**PLANNING**

Project: **TWICKENHAM STADIUM EAST STAND EXTENSION**

Drawing title: **TYPICAL STREET FRONTAGE 1**

Project number 15735 Drawing number 241 Revision P02

**1 ELEVATION**  
 STREET FRONTAGE DETAILED ELEVATION 1  
 1 : 50

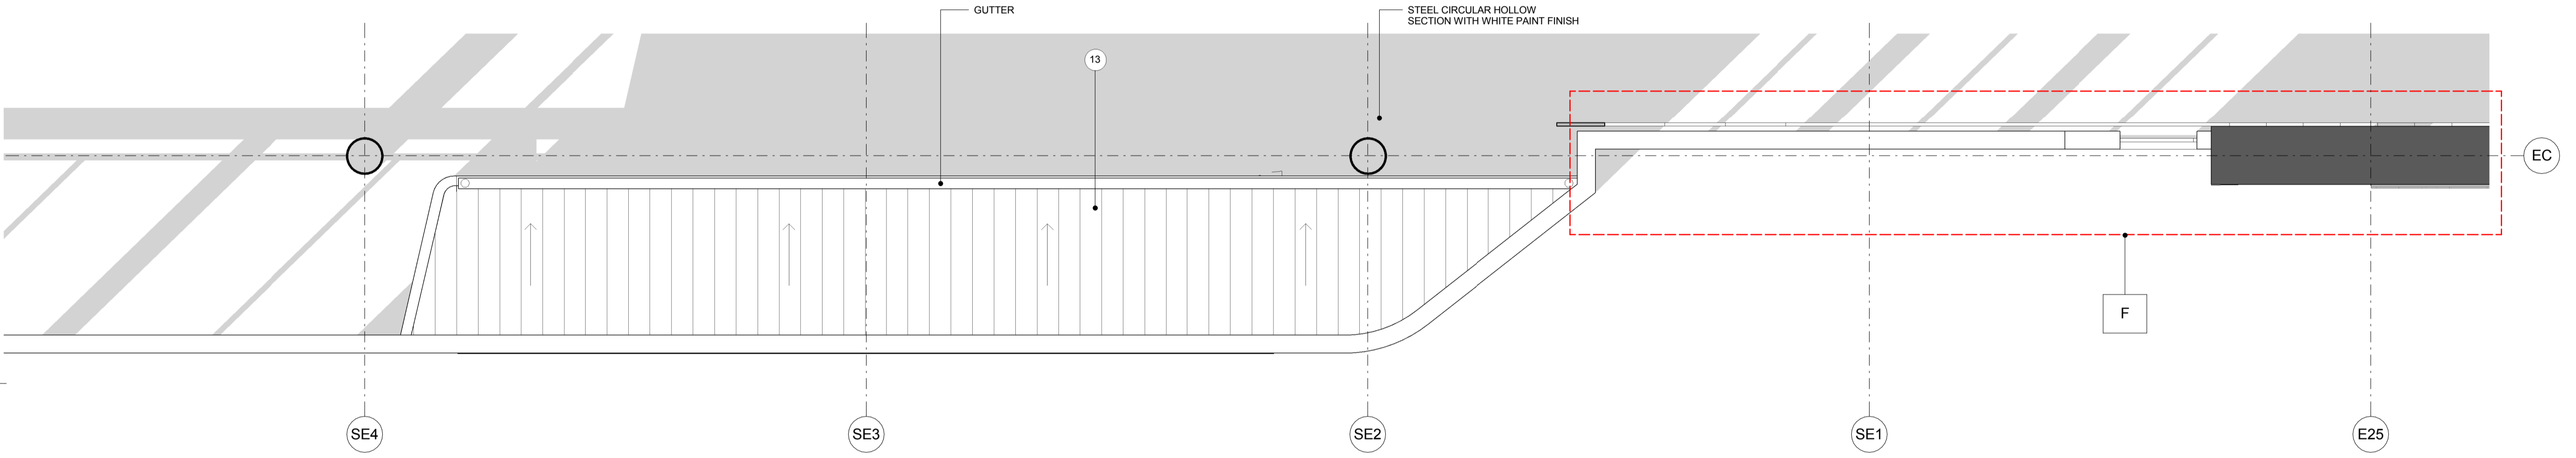
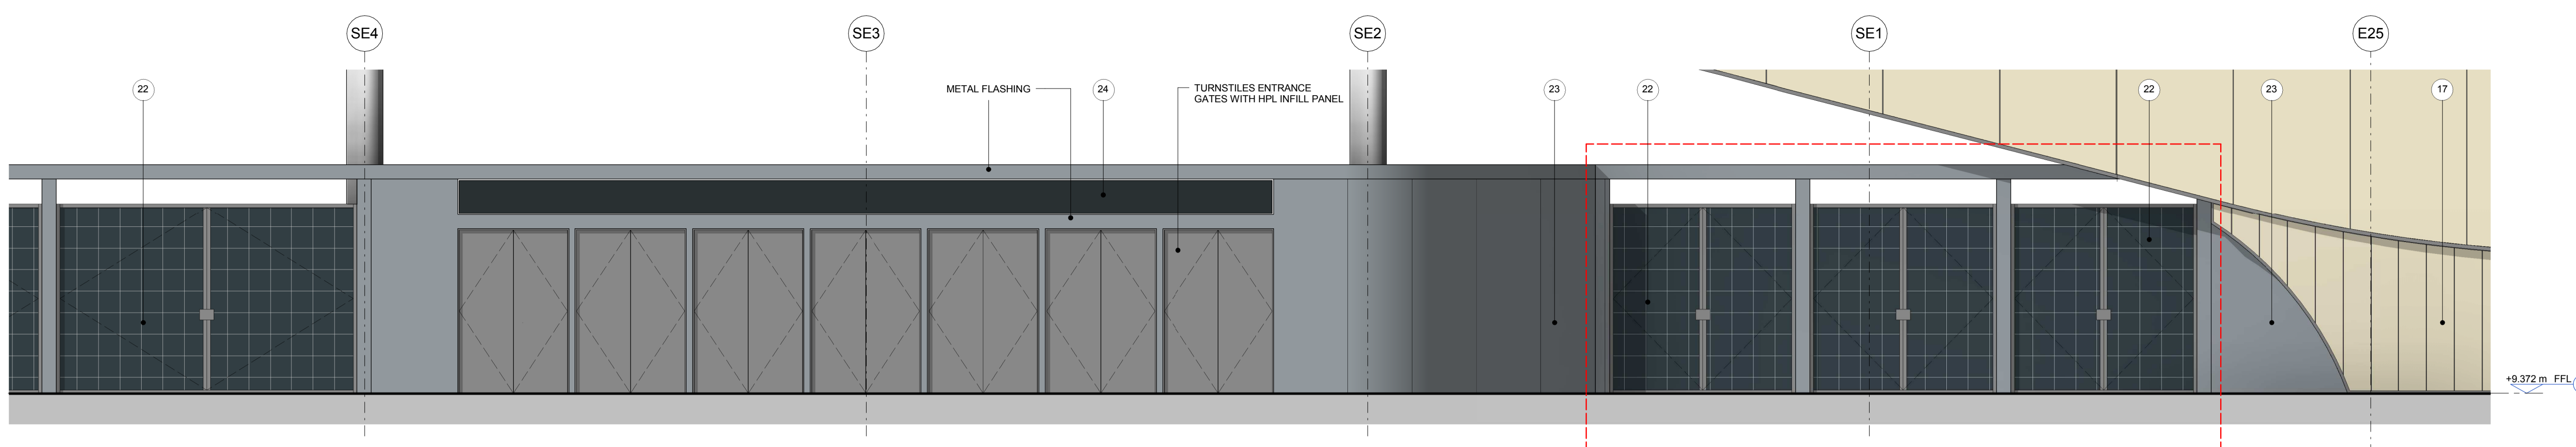
- PLANNING AMENDMENTS**
- A GENERAL AMENDMENTS TO THE SOUTH END. INCREASED SHINGLES CLADDING AREA AND CURTAIN WALL REDUCED ACCORDINGLY.
  - A1 REDUCED MASSING AND REVISED INTERFACE WITH THE SOUTH STAND.

- A2 PPC LOUVRES LOCATED TO THE BOWL SIDE HAVE BEEN OMITTED.
  - B CURTAIN WALL SETTING OUT REVISED GENERALLY. SILICONE JOINTS TO TRANSOMS AND MULLION REPLACED WITH GAPPED SYSTEM. LEVEL 04 PPC LOUVRES SETTING OUT & HEIGHT REVISED. MONORAIL FOR ABSAILING REMOVED.

- C GENERAL AMENDMENTS TO THE CENTRAL ELEVATION CANOPY AT LEVEL 5A REVISED GENERALLY AND STANDING SEAM REPLACED WITH SINGLE PLY MEMBRANE. SUPPORT COLUMNS TO ROOF CANOPY REVISED. SQUARE FASCIA TO ROOF EDGE.

- D LEVEL 5A GLAZED SCREEN EXTENDED IN HEIGHT AND PPC LOUVRES INCLUDED AT LOW LEVEL.
  - D1 INCREASED SHINGLES CLADDING AREA AND CURTAIN WALL AREA REDUCED ACCORDINGLY. FOUR VERTICAL FINS REMOVED.

- D2 PORCELAIN PANELS WITH SLOTTED HOLES FOR VENTILATION REPLACED WITH PPC LOUVRES. EXPRESSED HORIZONTAL PATTERN TO PORCELAIN PANELS OMITTED.
  - D3 GENERAL AMENDMENTS TO THE NORTH END PORCELAIN CLADDING REPLACED WITH PPC ALUMINIUM CLADDING.

- E GREEN WALL TO THE NORTH END EXTENDED AND PPC LOUVRES REMOVED.
  - E1 INCREASED SHINGLES CLADDING AREA AND CURTAIN WALL REDUCED ACCORDINGLY.
  - E2 FENCELINE, GATE AND PERIMETER COLUMNS SETTING OUT REVISED.

- E3 CANOPY TO TURNSTILES REVISED.
  - F PORCELAIN PATTERN CHANGED FROM HORIZONTAL TO VERTICAL.
  - F1 PORCELAIN PANELS TO THE SOFFIT OF THE ARCH REPLACED WITH PPC ALUMINIUM PANELS. PORCELAIN PANELS SETTING OUT REVISED.

- G ROOF TO LEVEL 5A (NORTH END) EXTENDED. GLAZED SPANDREL PANELS REPLACED WITH METAL SPANDREL PANEL. PORCELAIN PANELS REPLACED WITH PPC ALUMINIUM CLADDING.

- H PPC LOUVRES INCLUDED FOR MECHANICAL VENTILATION.
  - L1
